**Freightliner
Service Bulletin**

General Information

Fig. 1, SmartShift Control

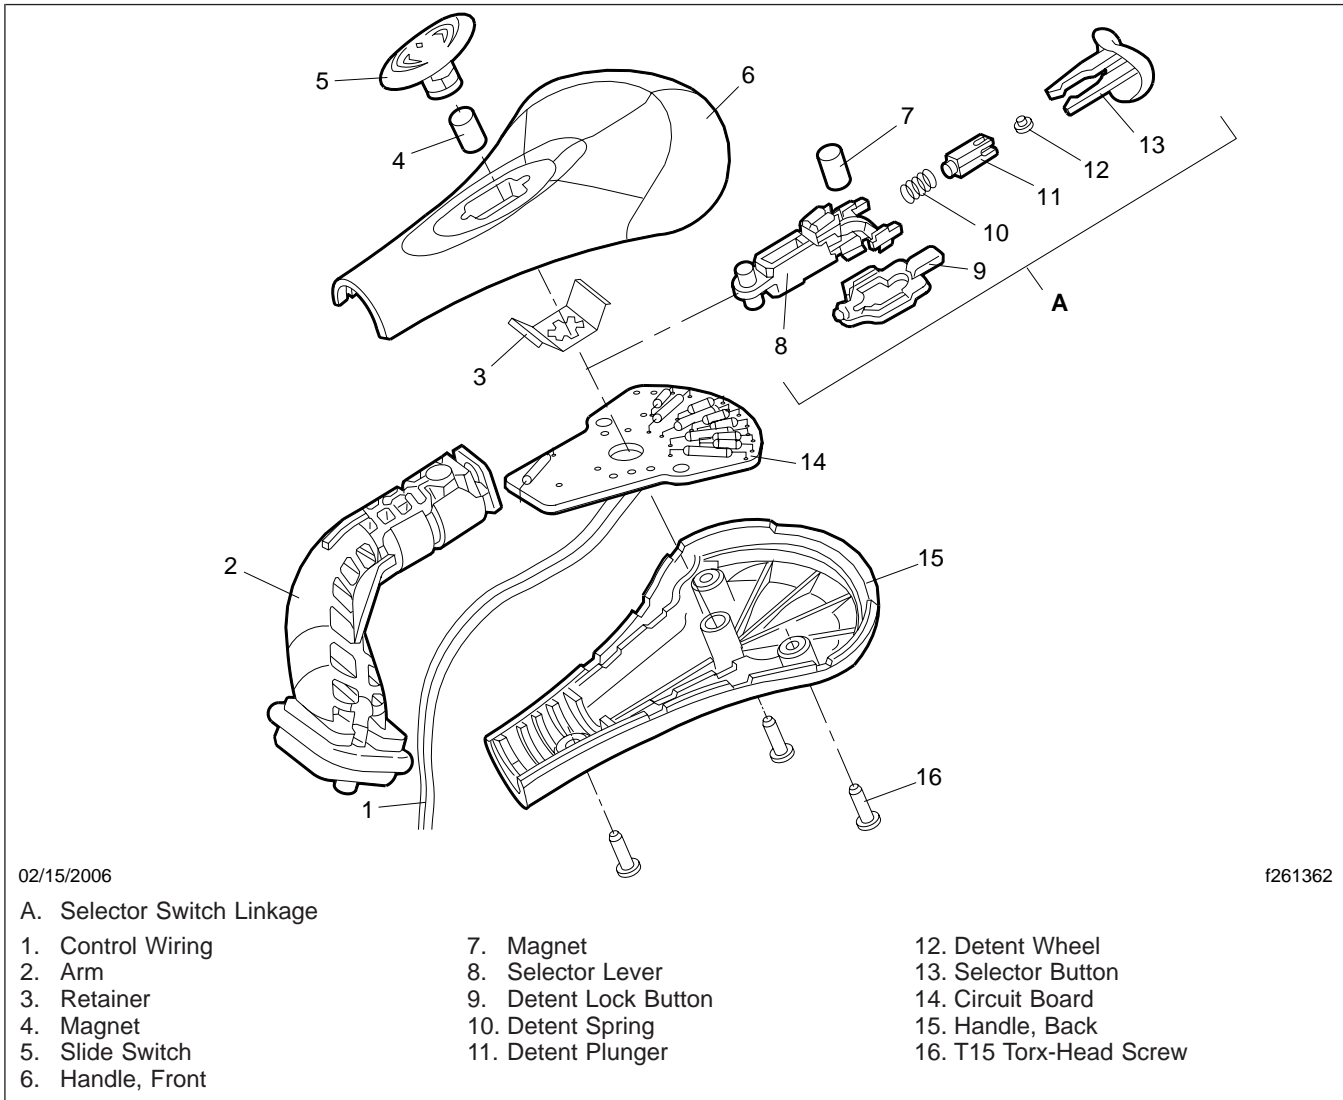
Some vehicles equipped with a SmartShift™ transmission shift control may have the drive mode slide switch loosen or detach. The slide switch has been redesigned, and vehicles produced after January 1, 2006 have the redesigned switch.

IMPORTANT: When removing the front handle assembly, be careful not to displace any of the linkage for the selector switch. If the linkage is displaced or the back of the handle becomes unattached, see [Fig. 1](#) for a diagram that shows the correct orientation of the components.

3. Using a free hand to ensure the back cover remains attached to the arm, carefully remove the front handle assembly. Discard the front handle assembly.
4. Ensure that the circuit board, selector lever, and wiring are placed in their proper locations.

5. Install the new front handle assembly.
6. Install the three Torx screws through the back of the SmartShift body. Tighten until snug.
7. Verify that the SmartShift functions properly.
